**UMMC PROJECT NO. 409-007
FIRE PROTECTION CENTRAL CORE
UNIVERSITY OF MISSISSIPPI MEDICAL CENTER
JACKSON, MISSISSIPPI**

Addendum No. 1

August 5, 2026

This addendum forms a part of the contract documents and modifies the original plans and specifications dated June 12, 2026.

FP401

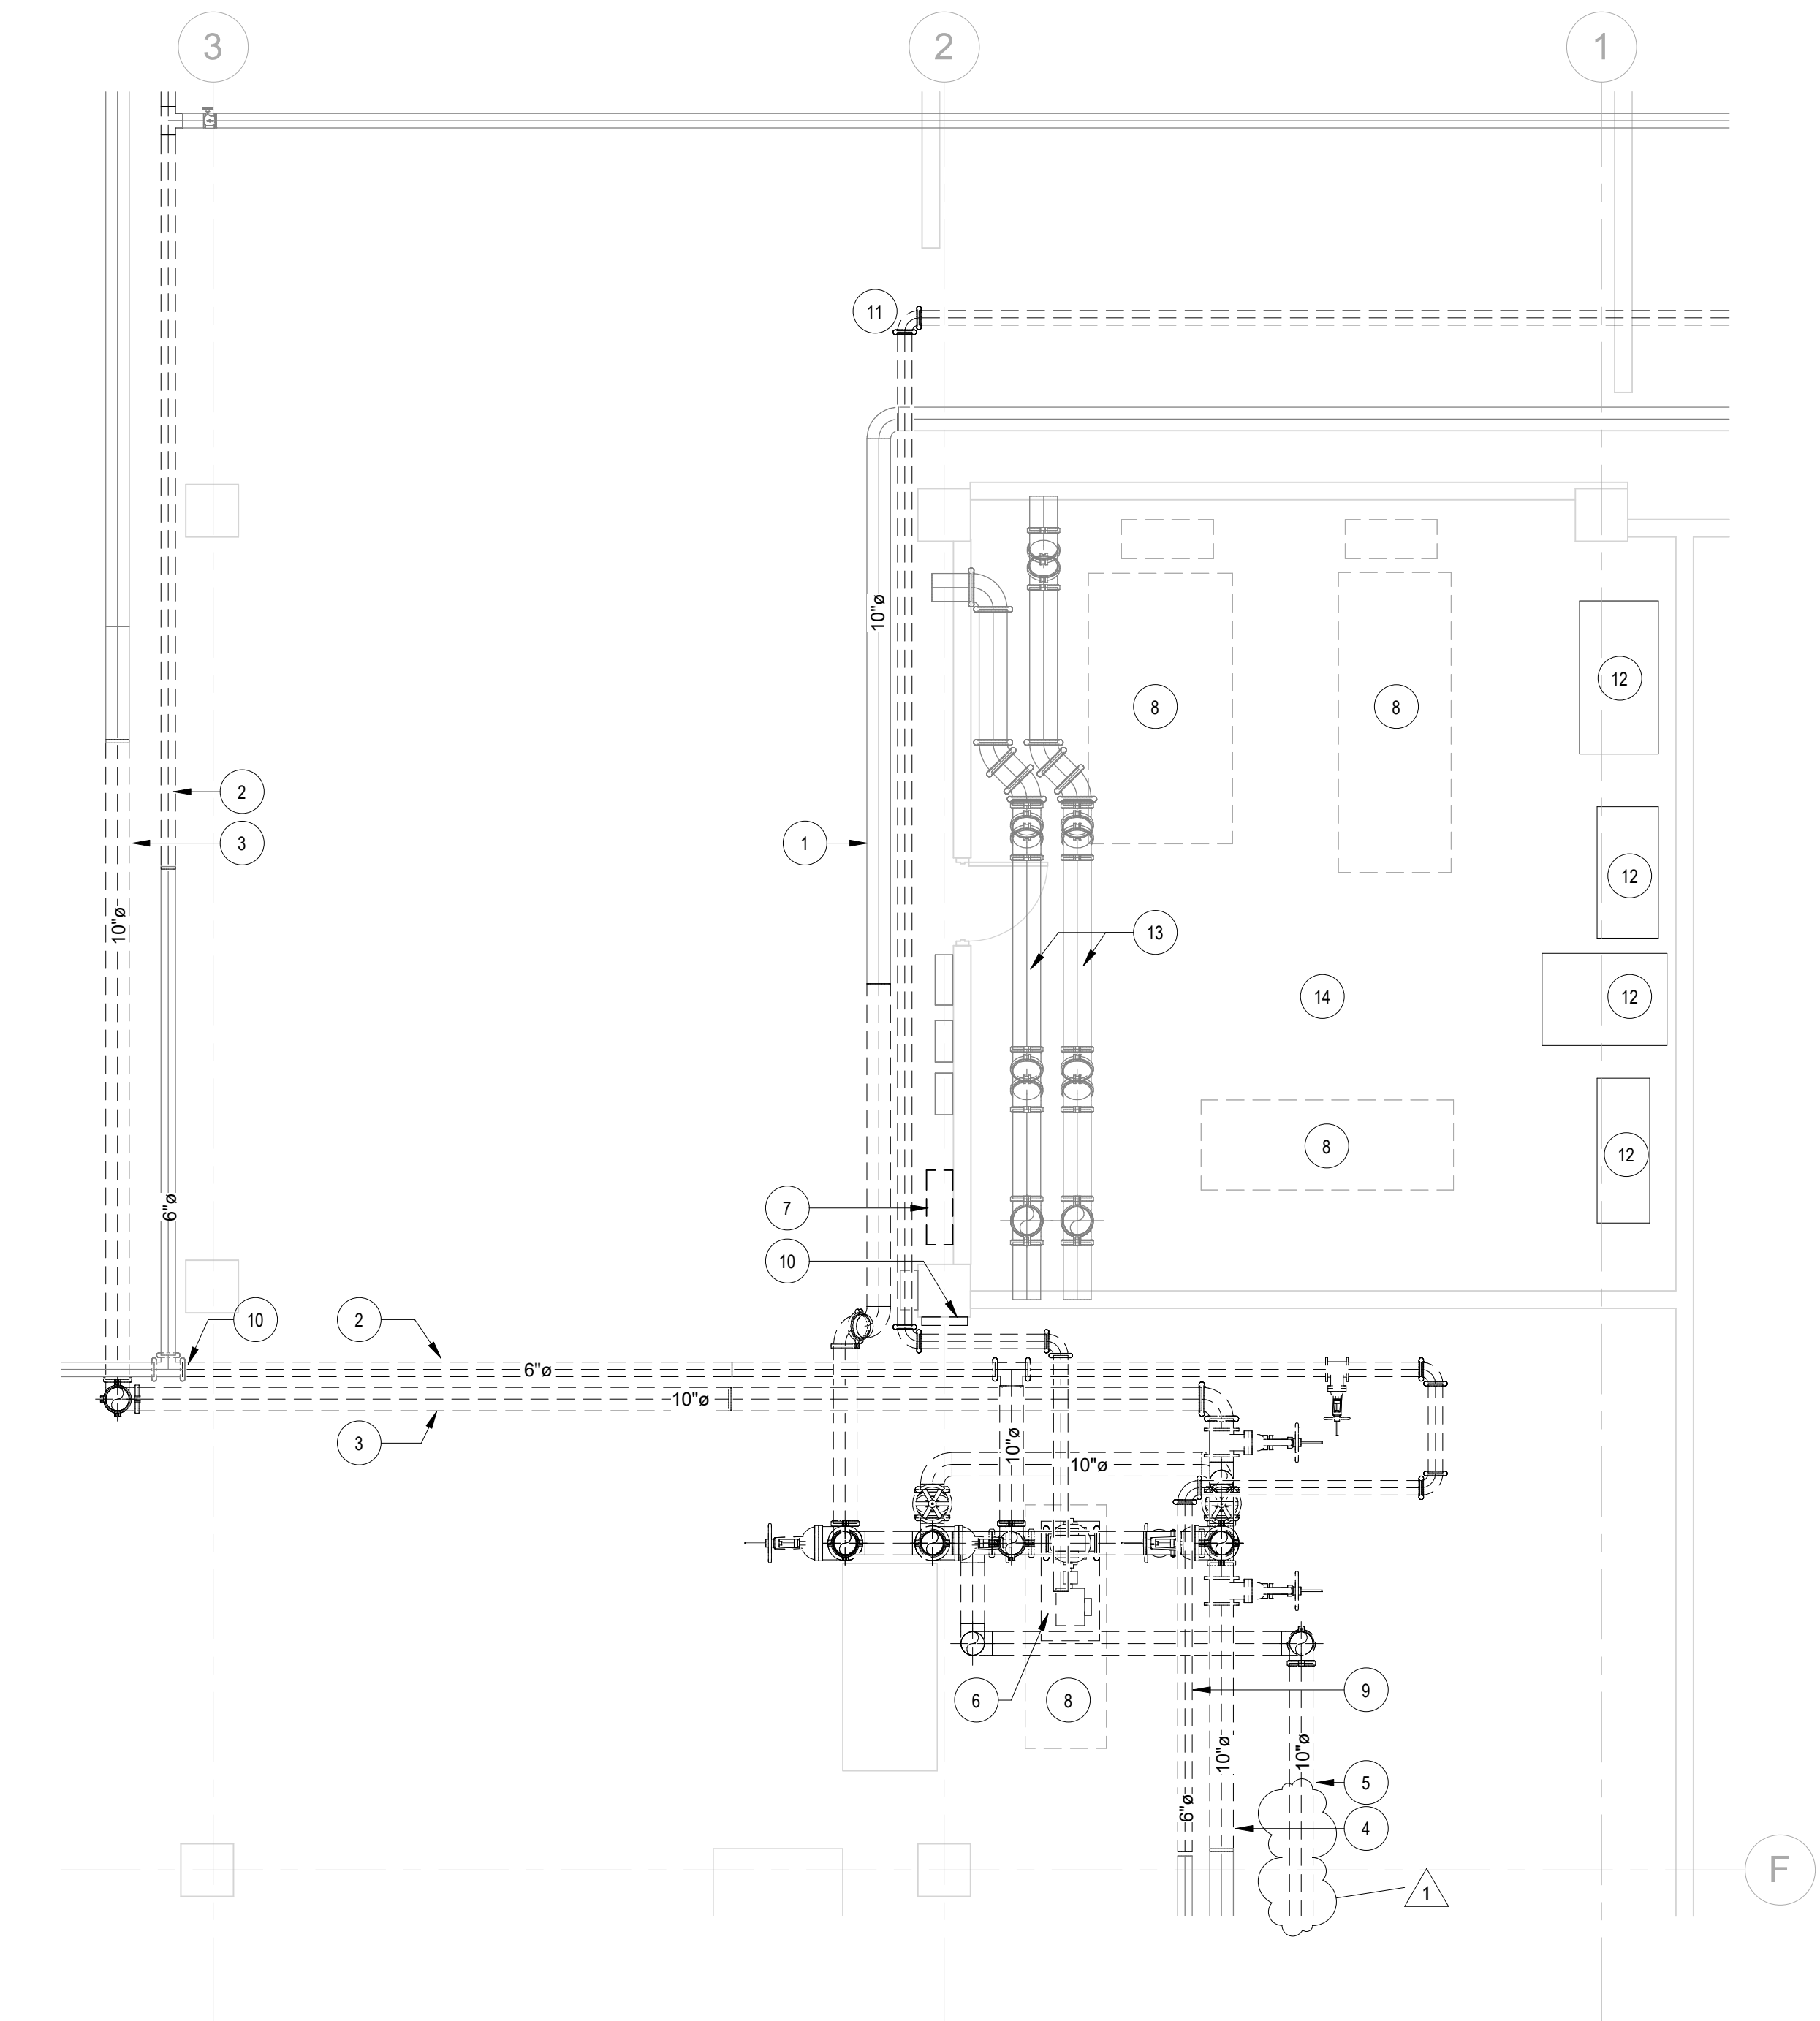
- 1. New sprinkler zone scope boundary added.
- E. Sheet FP401, Fire Pump Enlargement Plans New Work
 - 1. New pressure relief piping removed.
 - 2. PRVs and connected piping increased in size from 6" to 8".

FIRE PUMP
ENLARGED
PLANS -
DEMOLITION
sheet no.
FP401-D

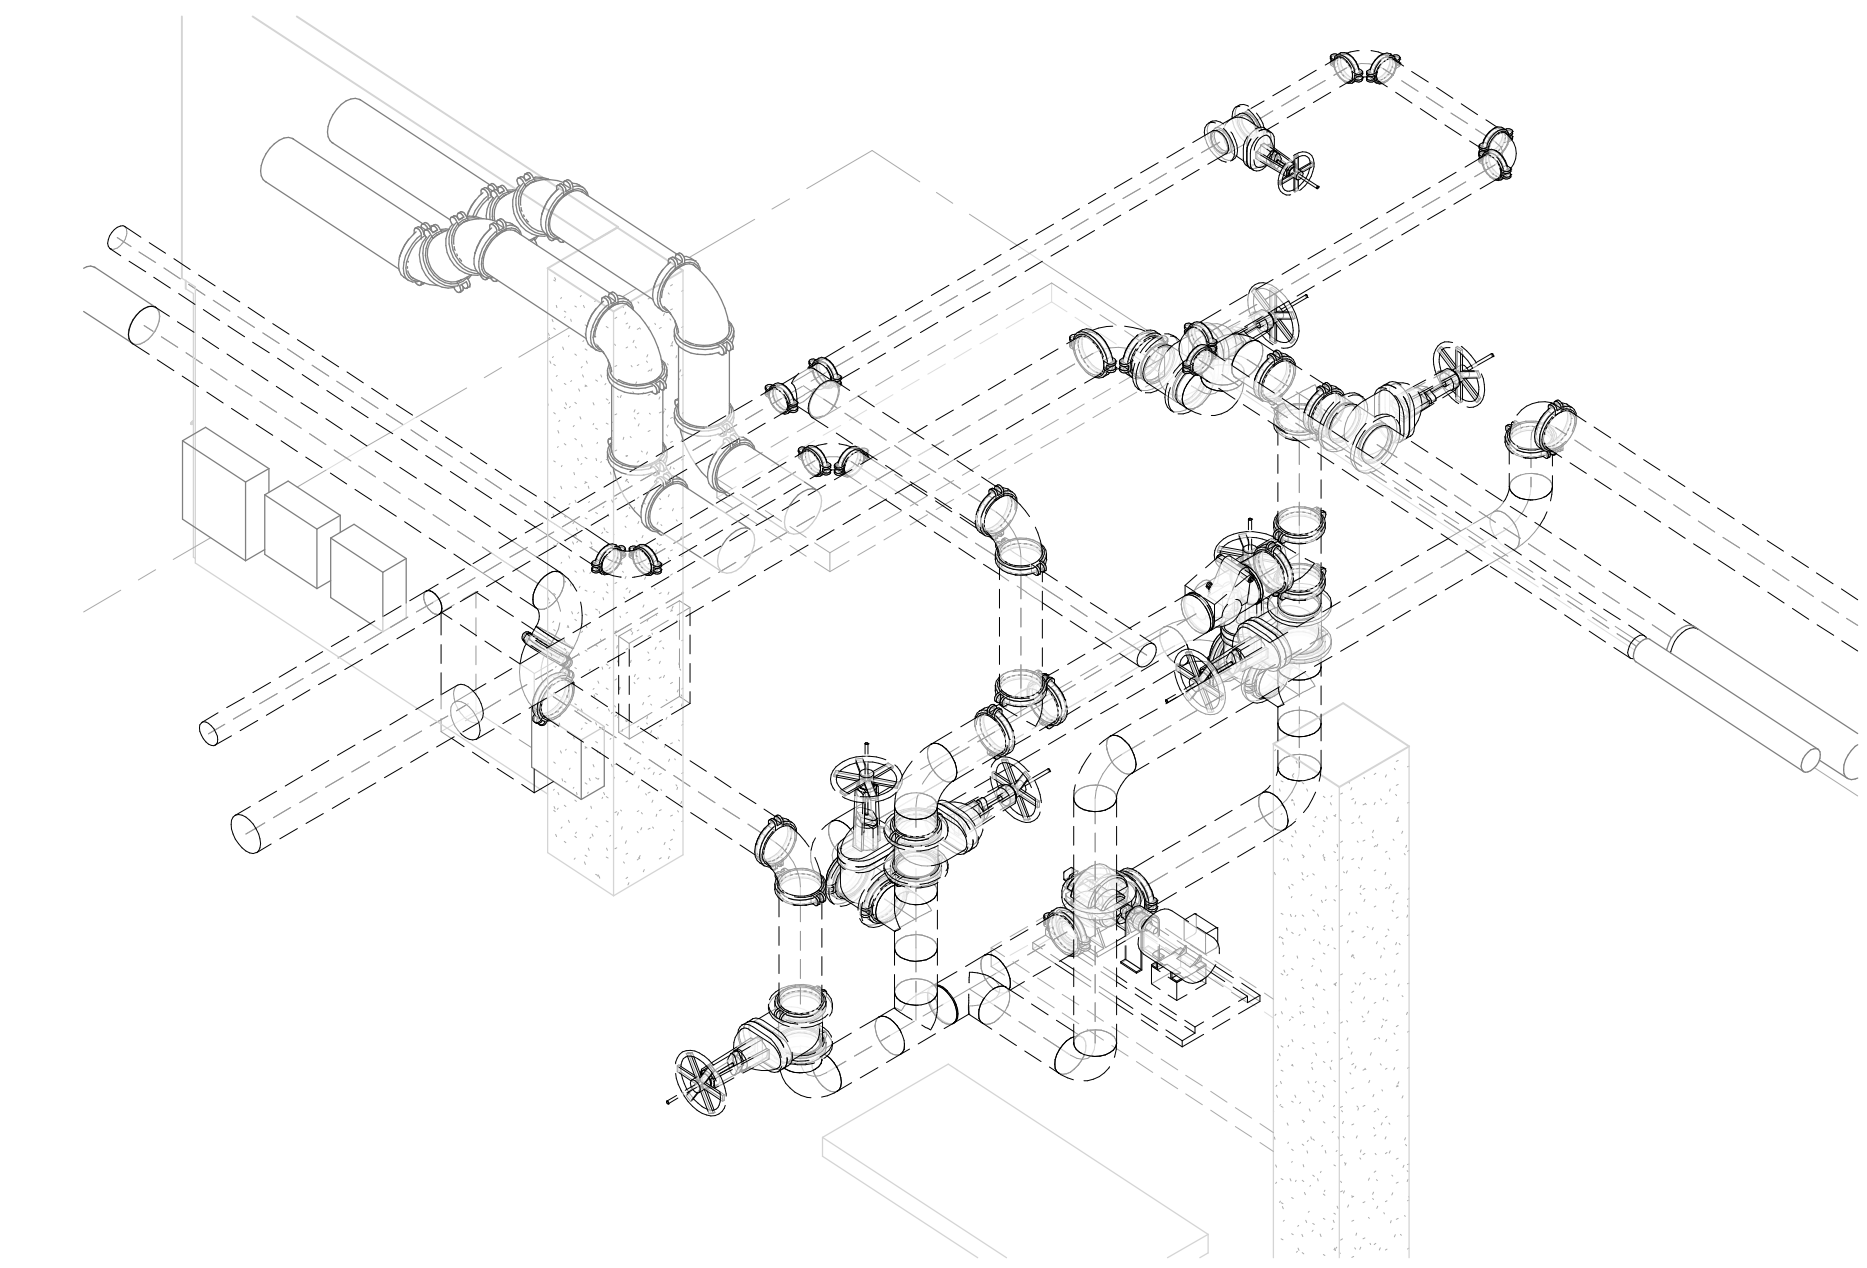
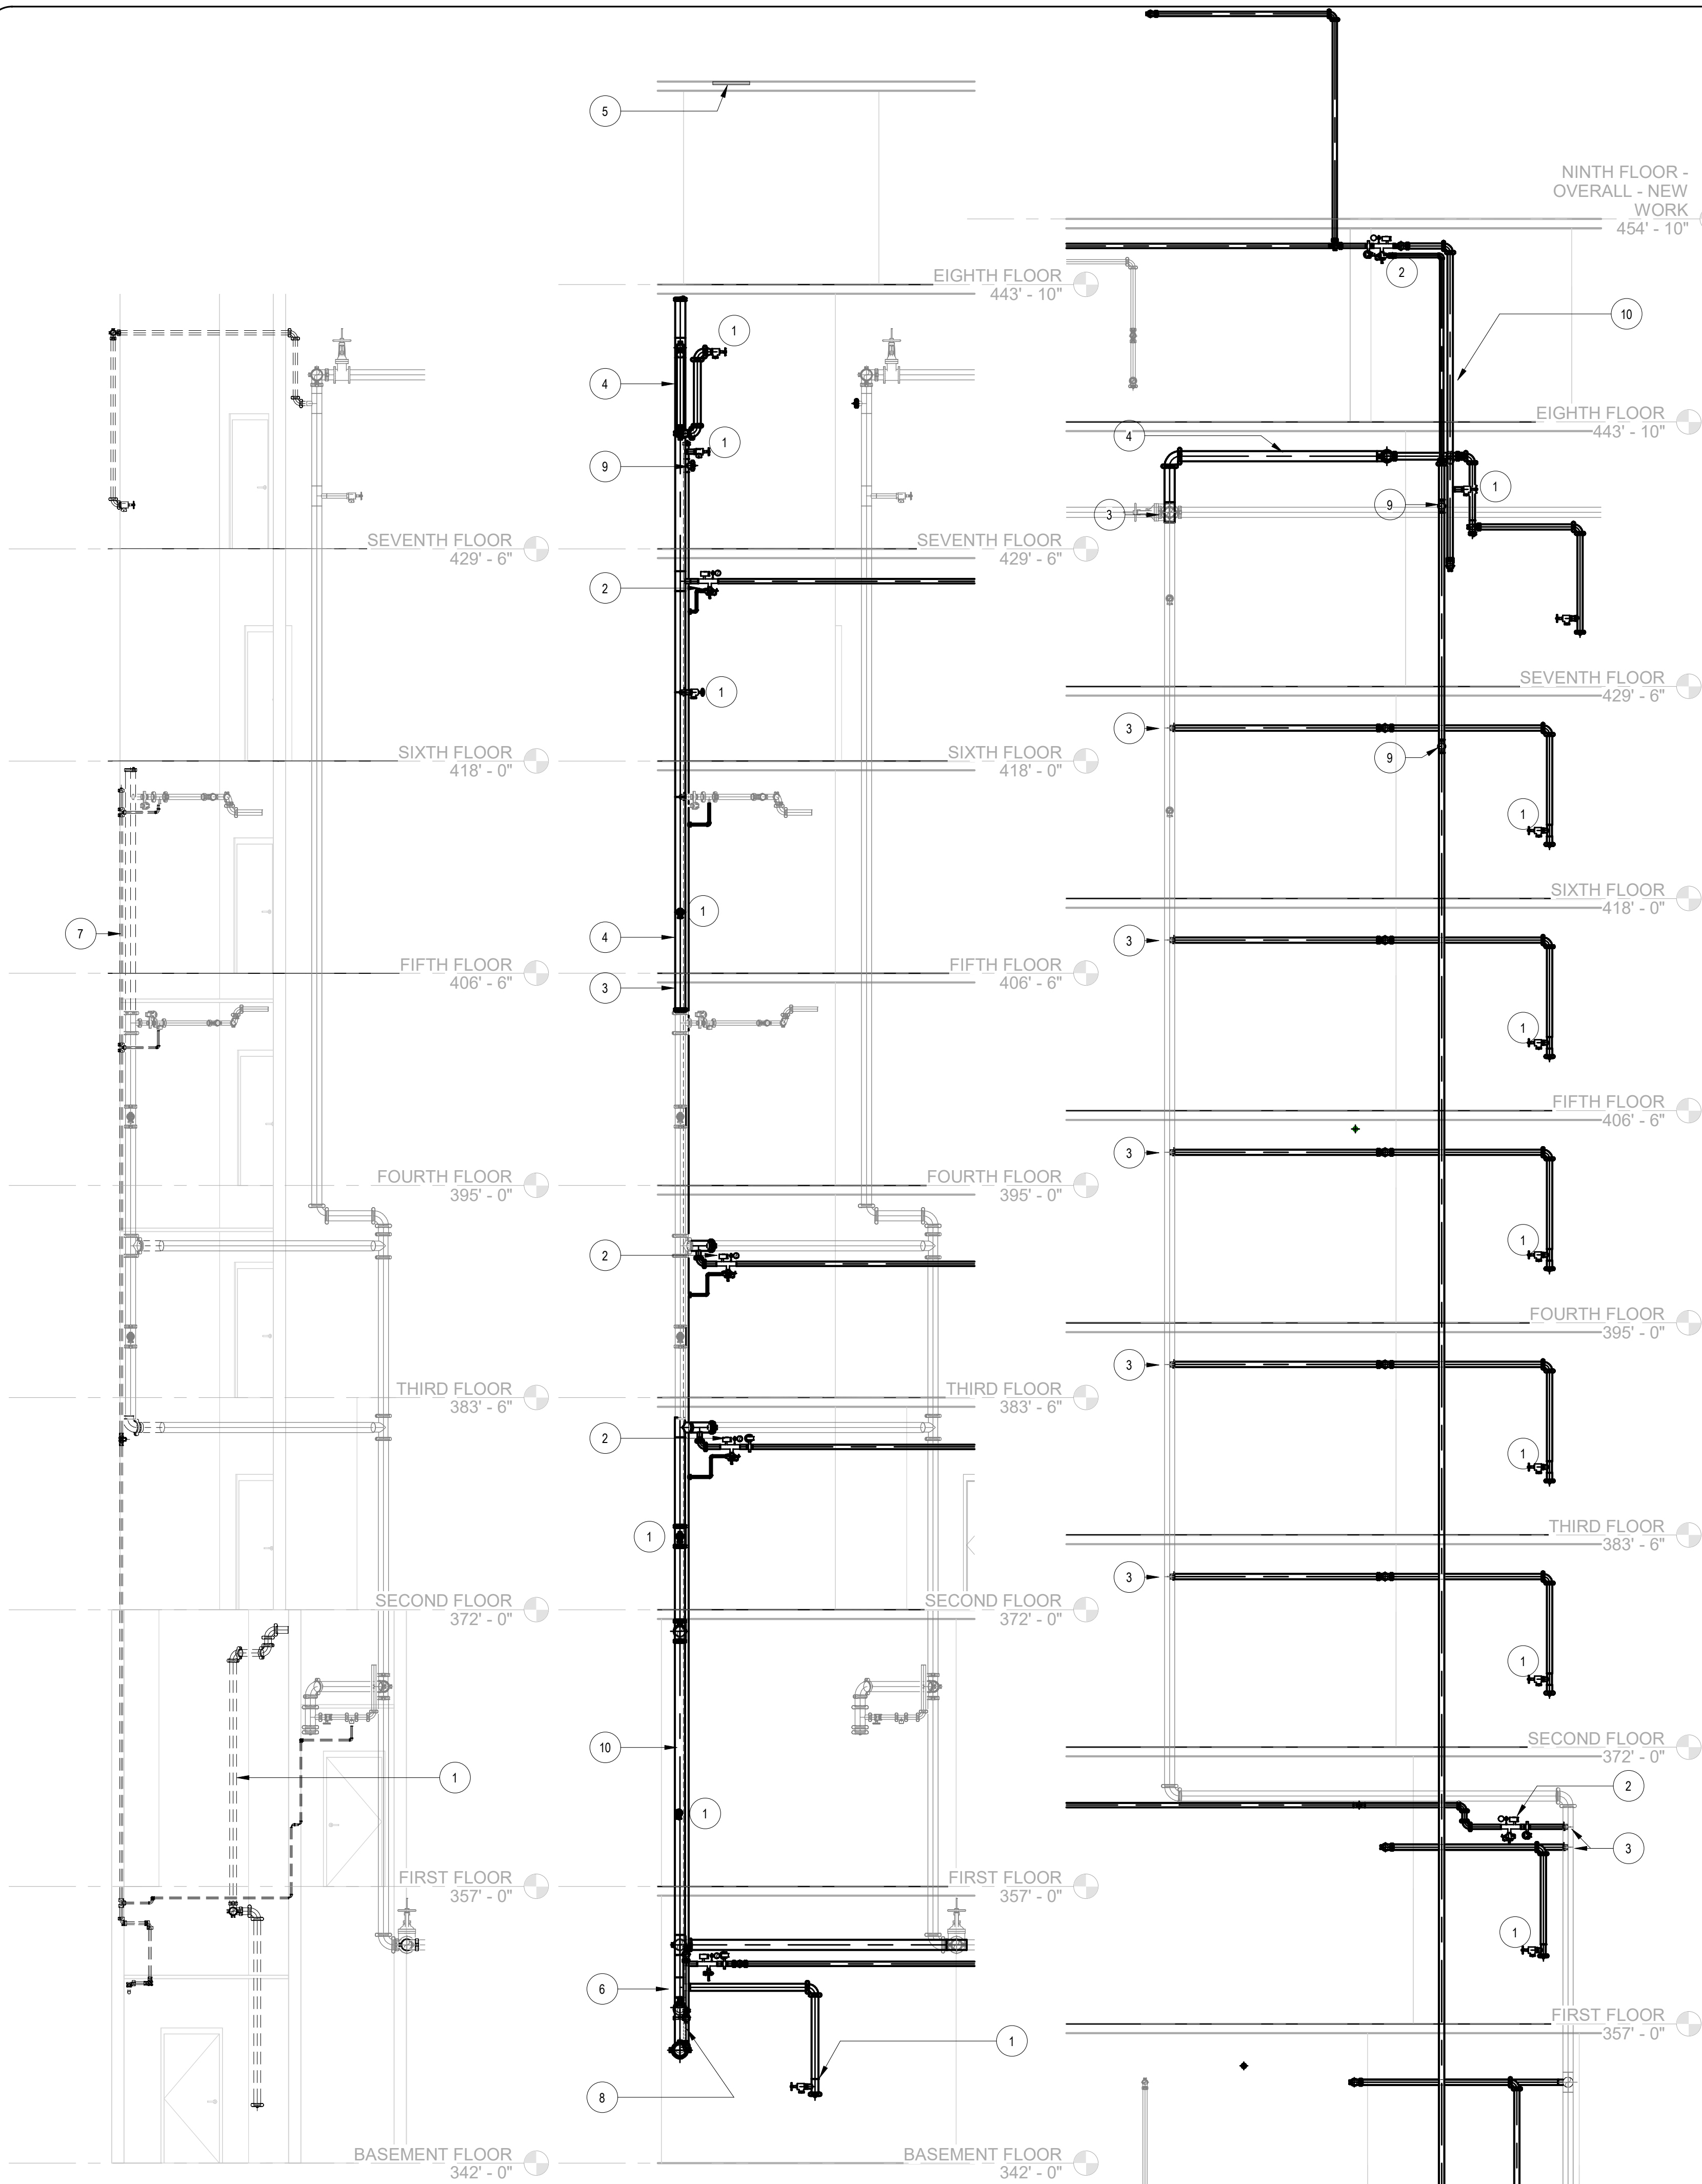
- F. Sheet FP401-D, Fire Pump Enlargement Plans Demolition
 - 1. Existing pressure relief piping demolished back to exterior wall and capped.
- G. Sheet FP601, Sections
